Access Compliance Report

Public Rights-of-Way

(Curb Ramps)

Intersection ID: 18234	Main Street: PARK_RD	Cross Street: E_WOODLAWN_RD	Location: NE
ADA ID: 1B6B0C811932	Ramp Type: Perp	Initial Pass/Fail: Fail	Overall Compliance: No
Severity Score: 12.5			
Codes/Mitigation Info/Possible Solution		Field Measurements/Component Compliance

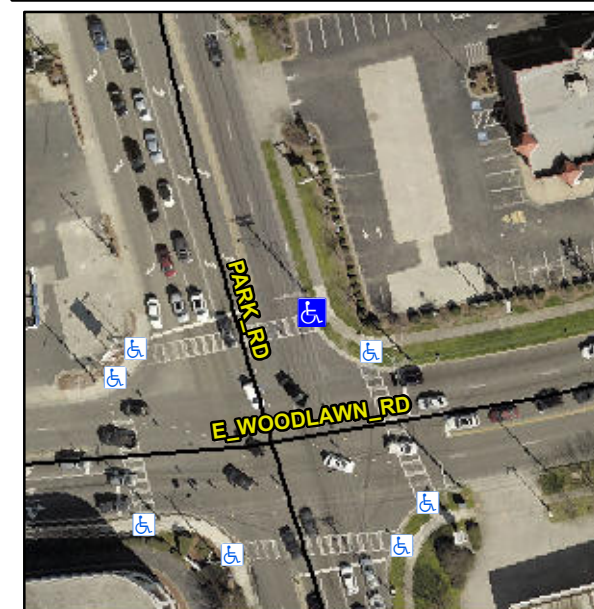
R304.2.2

Compliance	Description	Data	Compliance	Description	Data
N/A	Ramp Length (in)	58.0	No	Ramp Slope (%)	9.5
Yes	Ramp Width (in)	59.0	Yes	Ramp XSlope (%)	0.3
N/A	Flare Type LT	N/A	N/A	Flare Type RT	N/A
N/A	Flare Slope LT (%)	N/A	N/A	Flare Slope RT (%)	N/A
N/A	Flare Traversable LT?	N/A	N/A	Flare Traversable RT?	N/A
N/A	Landing Length (in)	N/A	N/A	DWS Provided?	N/A
N/A	Landing Width (in)	N/A	N/A	DWS Contrast?	N/A
N/A	Landing Slope (%)	N/A	N/A	DWS Length (in)	N/A
N/A	Landing X Slope (%)	N/A	N/A	DWS Full Width?	N/A
N/A	Landing Curb? (Y/N)	N/A	N/A	DWS Offset (in)	N/A
N/A	Shared Landing?	N/A			
N/A	Gutter Ponding?	N/A	N/A	Gutter Slope (%)	N/A
N/A	Gutter Lip Ht (in)	N/A	N/A	Gutter X Slope (%)	N/A
N/A	Painted X Walk1?	Yes	N/A	Painted X Walk2?	N/A
	X Walk 1 Direction	To W		X Walk 2 Direction	N/A
N/A	X Walk 1 Width (in)	103.0	N/A	X Walk 2 Width (in)	N/A
	X Walk 1 Slope (%)	5.1		X Walk 2 Slope (%)	N/A
	X Walk 1 X Slope (%)	2.0		X Walk 2 X Slope (%)	N/A

Remove & Replace Entire Ramp.
